STATE OF UTAH DEPARTMENT OF NATURAL RESOURCES DIVISION OF OIL, GAS AND MINING						FORM 3 AMENDED REPORT				
APPLICATION FOR PERMIT TO DRILL						1. WELL NAME and NUMBER Cactus Park 10-14-36-24

APD DRILLING PLAN

Cactus Park 10-14-36-24

Operator SUMMIT OPERATING, LLC
Well Name Cactus Park 10-14-36-24
API Number 43037500680000 **APD No** 9806 **Field/Unit** WILDCAT
Location:
1/4, 1/4 NWSE **Sec** 14 **Tw** 36.0S **Rng** 24.0E 1472 FSL 2259 FEL
GPS Coord
(UTM) **Surface Owner** Wagon Rod Ranch, LLC (Charlie Tracy, Representative)

Casing Schematic

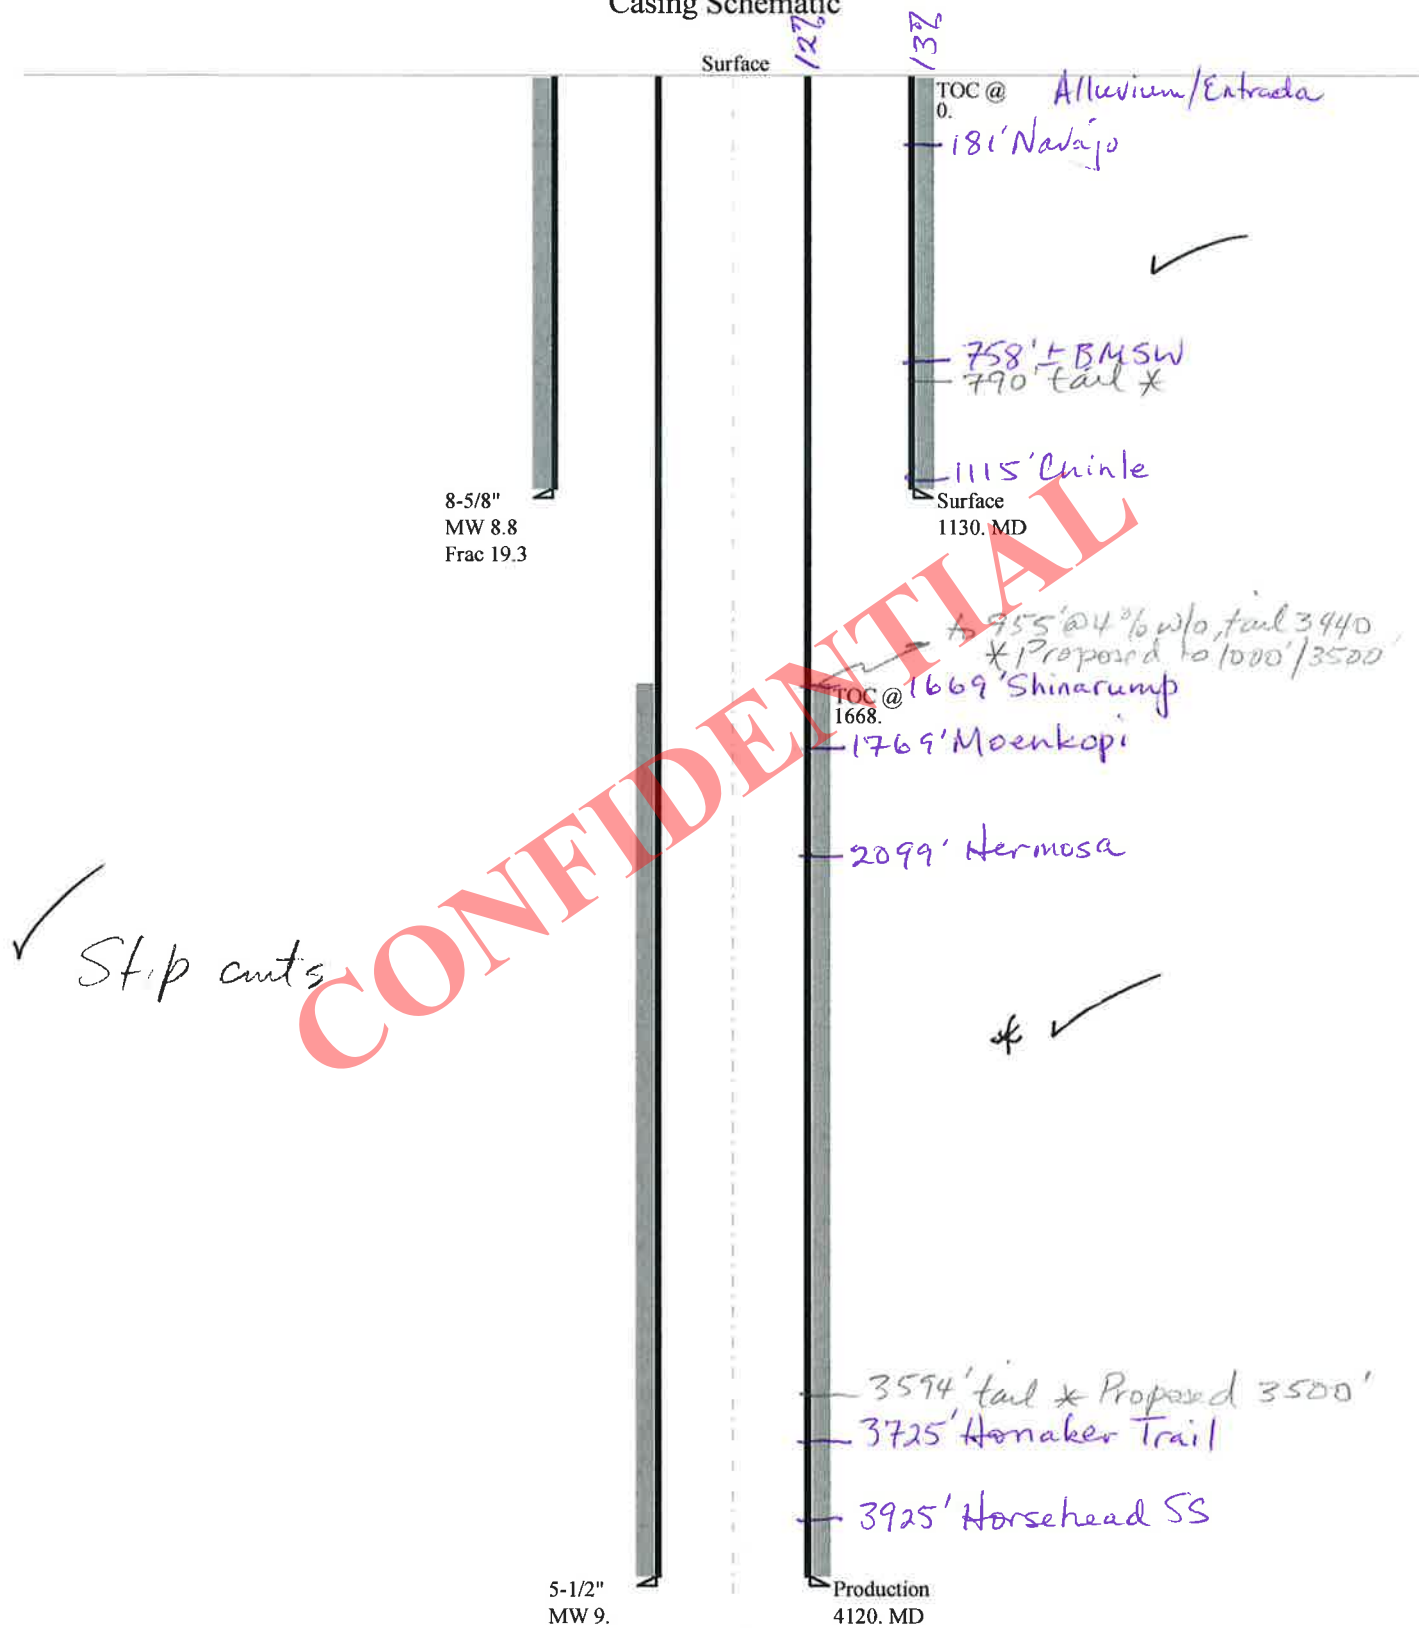
Collapse is based on a vertical depth of 1130 ft, a mud weight of 8.8 ppg. The casing is considered to be evacuated for collapse purposes. Collapse strength is based on the Westcott, Dunlop & Kemler method of biaxial correction for tension.

Burst strength is not adjusted for tension.

Collapse is based on a vertical depth of 4120 ft, a mud weight of 9 ppg. The casing is considered to be evacuated for collapse purposes. Collapse strength is based on the Westcott, Dunlop & Kemler method of biaxial correction for tension.

Burst strength is not adjusted for tension.
